REFERENCE:	TSB: 23-081-23 GROUP 23 - Body	Date:	July 6, 2023	REVISION:	-
VEHICLES AFFECTED:	2023 (WS) Grand Wagoneer/Wagoneer This bulletin applies to vehicles built on or after January 09, 2023 (MDH 0109XX) and on or before April 04, 2023 (MDH 0404XX) equipped with Sea Salt/Black (Sales Code D7) or Global Black (Sales Code X7).	MARKET APPLICABILITY:			
CUSTOMER SYMPTOM:	Mismatched front seat covers (one seat cover has a "SERIES 1" badge (Fig. 1) , the other has no badge). 2023 (WS) Grand Wagoneer/Wagoneer front seat covers do not have badges.				
CAUSE:	Model Year 2022 front seat covers installed.

Fig. 1
Incorrect "SERIES 1" Badge Front Seat Cover

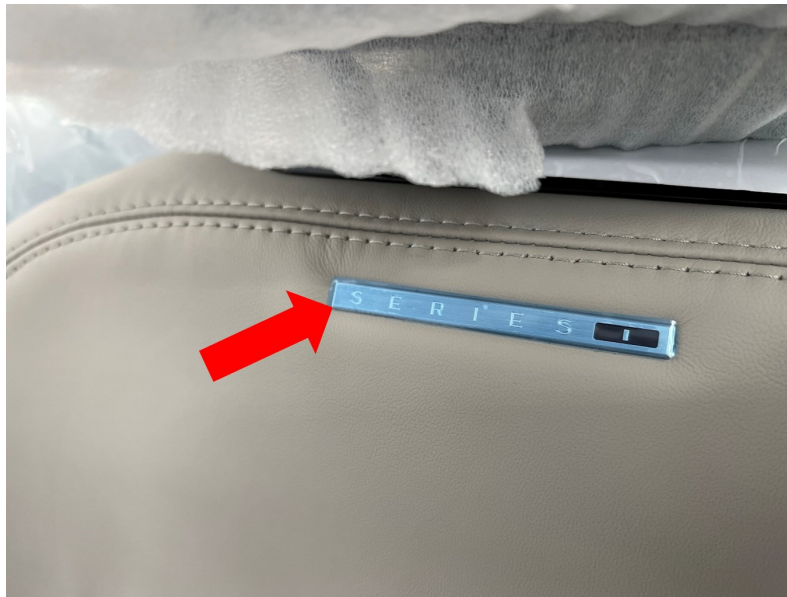
This bulletin involves replacing one front seat cover containing the "SERIES 1" badge.

NOTE: Only replace the one front seat cover with the badge.

1. Replace the front seat cover that has the "SERIES 1" badge as required. Refer to the detailed service procedures available in DealerCONNECT/Service Library under: Service Info>23 - Body / Seats, Front / Cover, Seat Back, Front / Removal and Installation.
